PRODUCT SUPPORT BULLETIN BULLETIN NO. 313

MACHINE: **Super B and Super B-2 Spike Driver
Model 44 Spike Driver
Hydra-Hammer Model A, B and B-2 Spike Driver
Anchor Applicator Model E
Anchor Remover
Grabber Spike Puller (3" Axle Only)**

SUBJECT: **Split Axle Sprocket – 3" Diameter Internal Drive Axles**

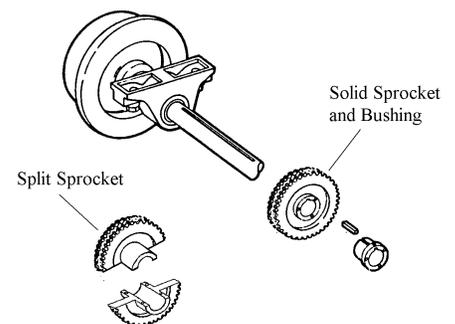
A split axle sprocket is now available for these machines to replace the one-piece solid sprocket previously used. The split sprocket will allow quick replacement of the sprocket without removing the wheels and bearings from the axle.

The Spike Drivers, Anchor Remover and Anchor Applicator will use **28-tooth split sprocket p/n 75120399**. This will replace the one-piece sprocket, p/n 75120400, and taper lock bushing, p/n 73040370.

The Grabber will use **20-tooth split sprocket, p/n 75100371**. This will replace the one-piece sprocket, p/n 75120370, and taper lock bushing, p/n 73044300.

Any orders for solid sprocket **75120400** will be replaced with split sprocket **75120399**.

Any orders for solid sprocket **75120370** will be replaced with split sprocket **75100371**.
